PLANNING COMMISSION REGULAR MEETING AGENDA

THURSDAY NOVEMBER 2, 2023, 7:00 P.M.

SPRING HILL PLANNING COMMISSION ZONING and PRELIMINARY PLAT BRIDGER AT 207TH STAFF REPORT

Case #: PZD-000121-2023 Meeting Date: November 2, 2023

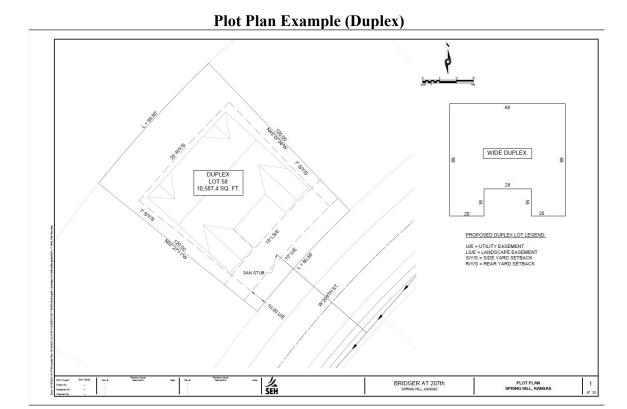
Staff has reviewed whether the parkland/open space is in conformance with the Spring Hill regulations. (See attached drawing showing the proposed park and open spare areas.)

- 1. The subdivision is required to provide 15 percent of public or private active open space. The applicant has identified all Tracts with a total of 10.7 percent or 55 accessible acres, as private open space and common areas. A trail running through the park land is listed as a public trail system that may connect to a regional trail system in the future.
- 2. The Comprehensive Plan does not show any trails in the area of this subdivision, so the addition of the public trail is a good amenity to the area that may be connected to a regional trail system throughout the community. This trail system would be required to be maintained by the home owners association. With the open space and trail system accessible to the general public, no park impact fees will be collected when a building permit is issued, if it remains at final plat.

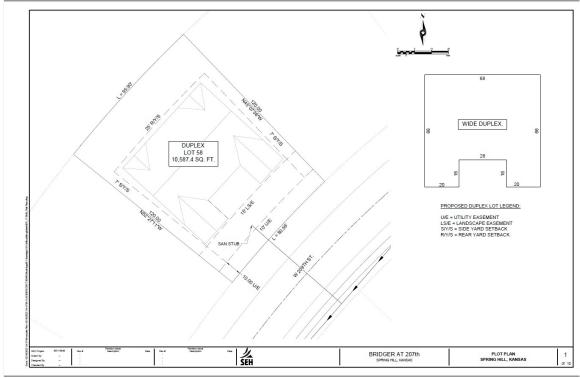
Staff has reviewed whether the parkland/open space is in conformance with the Spring Hill regulations. (See attached drawing showing the proposed park and open spare areas.)

- 1. The subdivision is required to provide 15 percent of public or private active open space. The applicant has identified all Tracts with a total of 10.7 percent or 55 accessible acres, as private open space and common areas. A trail running through the park land is listed as a public trail system that may connect to a regional trail system in the future.
- 2. The Comprehensive Plan does not show any trails in the area of this subdivision, so the addition of the public trail is a good amenity to the area that may be connected to a regional trail system throughout the community. This trail system would be required to be maintained by the home owners association. With the open space and trail system accessible to the general public, no park impact fees will be collected when a building permit is issued, if it remains at final plat.

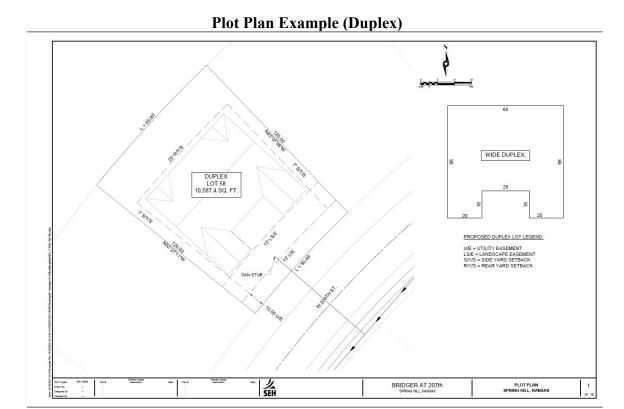
Staff has reviewed whether the parkland/open space is in conformance with the Spring Hill regulations. (See attached drawing showing the proposed park and open spare areas.)

- 1. The subdivision is required to provide 15 percent of public or private active open space. The applicant has identified all Tracts with a total of 10.7 percent or 55 accessible acres, as private open space and common areas. A trail running through the park land is listed as a public trail system that may connect to a regional trail system in the future.
- 2. The Comprehensive Plan does not show any trails in the area of this subdivision, so the addition of the public trail is a good amenity to the area that may be connected to a regional trail system throughout the community. This trail system would be required to be maintained by the home owners association. With the open space and trail system accessible to the general public, no park impact fees will be collected when a building permit is issued, if it remains at final plat.
